**Economic and Social Council**Distr.: General
22 December 2020

Economic Commission for Europe**Inland Transport Committee****World Forum for Harmonization of Vehicle Regulations****183rd session**

1958 Agreement:**Consideration of draft amendments to existing****UN Regulations submitted by GRVA****Proposal for the 02 series of amendments to UN Regulation
No. 152 (AEBS for M₁ and N₁)****Submitted by the Working Party on Automated/Autonomous and
Connected Vehicles***

Annex 2, amend to read (addition of a letter "B" in the marking and its reference in the text):

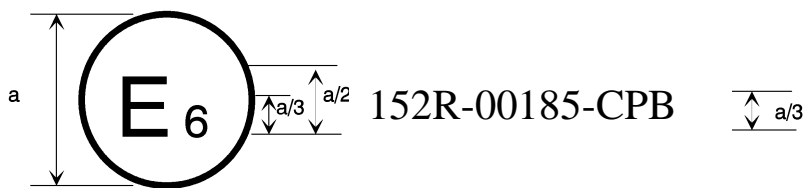
The above approval mark affixed to a vehicle shows that the vehicle type concerned has been approved in Belgium (E 6) with regard to the Advanced Emergency Braking Systems (AEBS) pursuant to UN Regulation No. 152 (marked with C for Car to Car, P for Car to Pedestrian, B for Car to Bicycle). The first two digits of the approval number indicate that the approval was granted in accordance with the requirements of UN Regulation No. 152 in its original form."
